Kirkham Residence 67 Grace Drive, Powell Ohio 43065

3 Pillar Homes' design for the Kirkham Family home located at 67 Grace Drive has been updated to include the following revisions based on the feedback from the Review Board in conjunction with the Architectural Guidelines for the Historic Overlay District:

**FRONT ELEVATION**

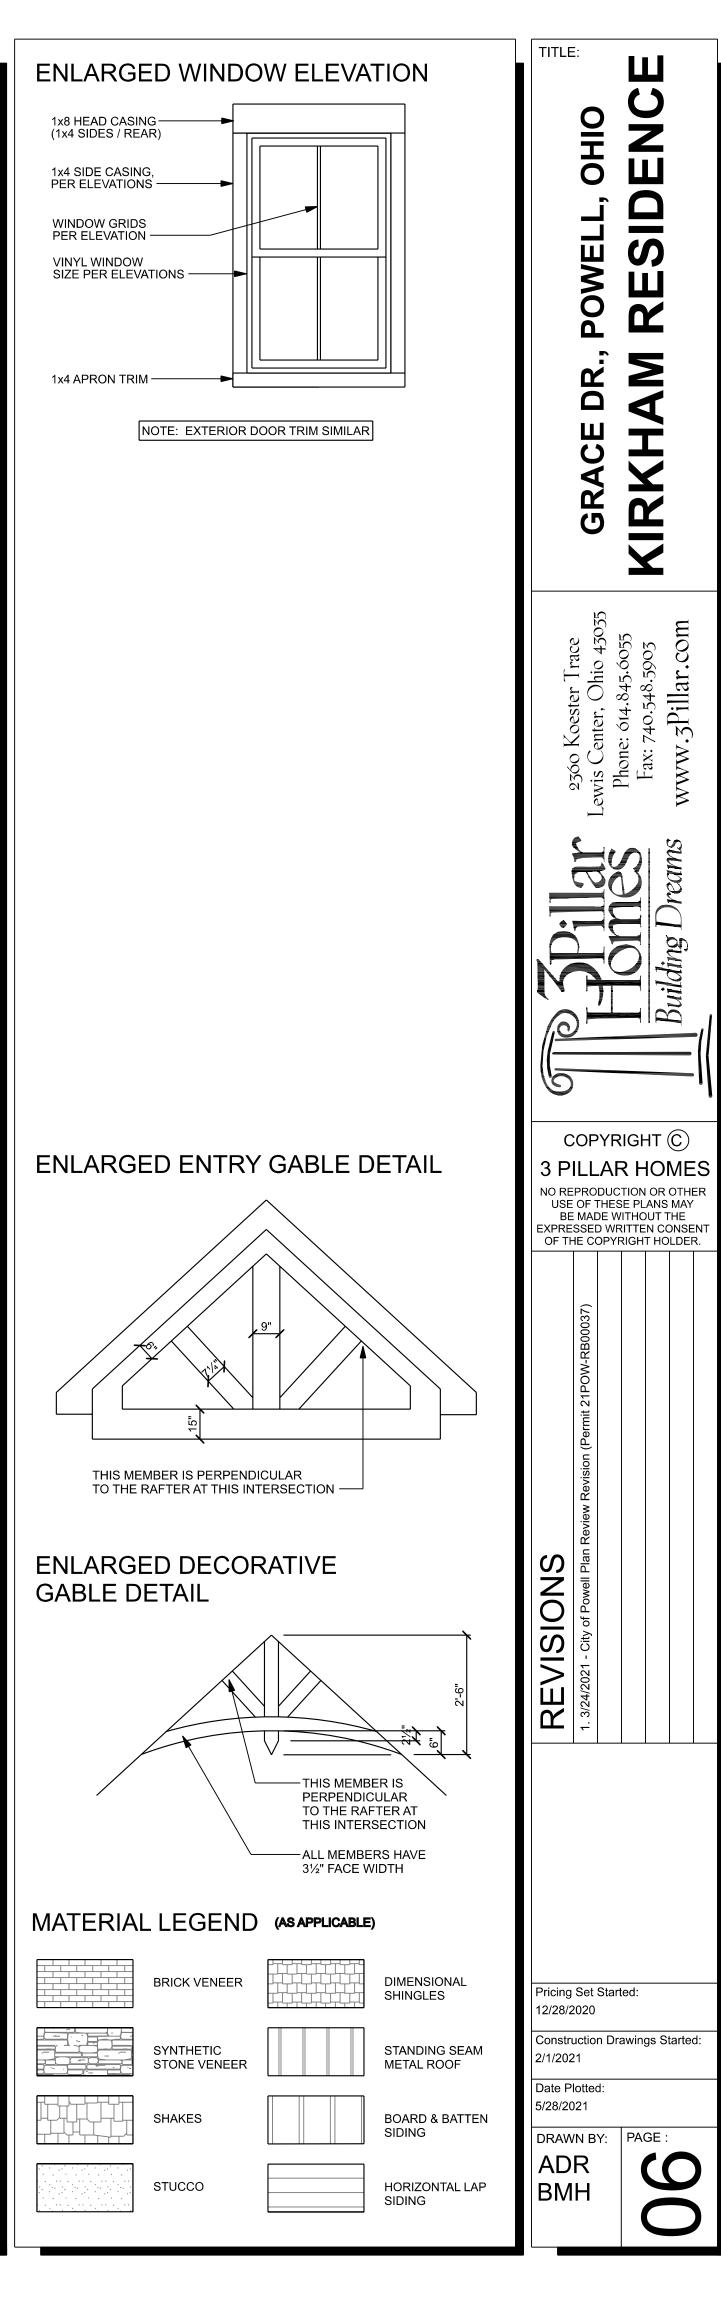
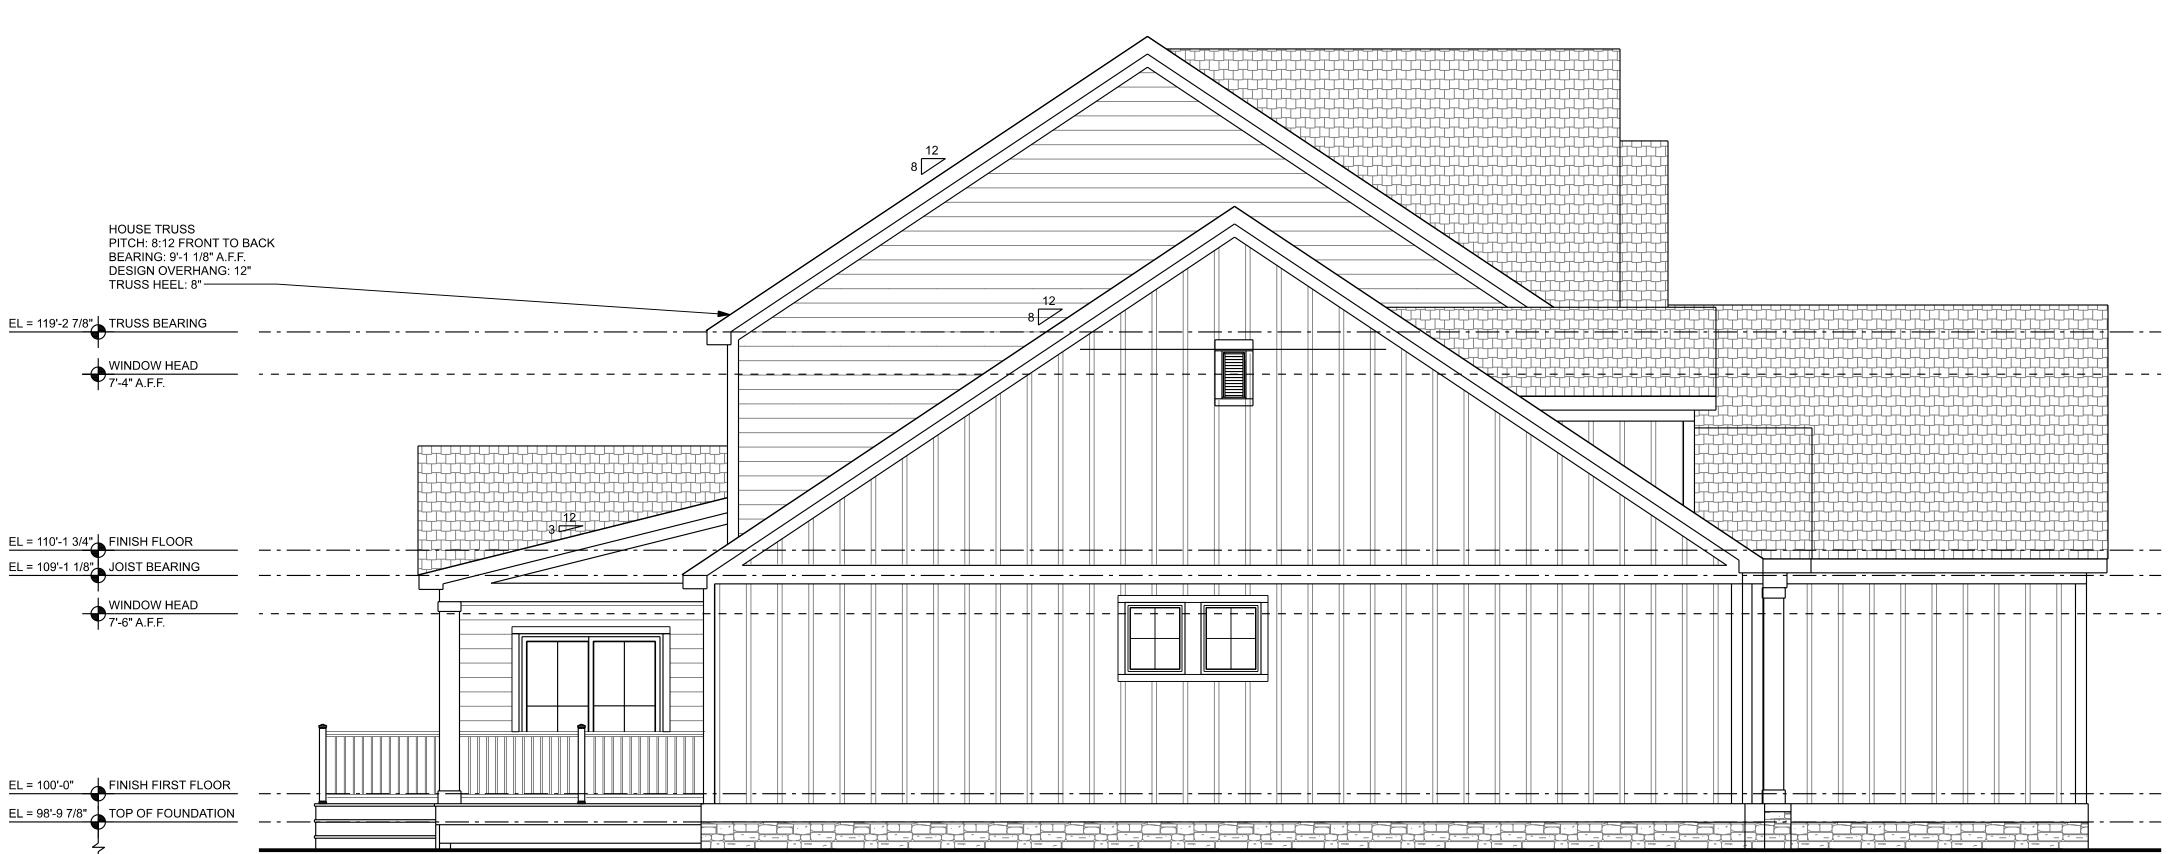
- 1. Extension of the Board & Batten siding around the sides of the home.
- 2. Window mullions matching the primary elevation on secondary elevations.
- 3. Removal of flanking windows to window above main garage door.
- 4. Window sizes revised to meet more appropriate vertical proportions.
- 5. Front doors revised to ¾-lite to match districts 'Alternative Doors for New Construction' options.
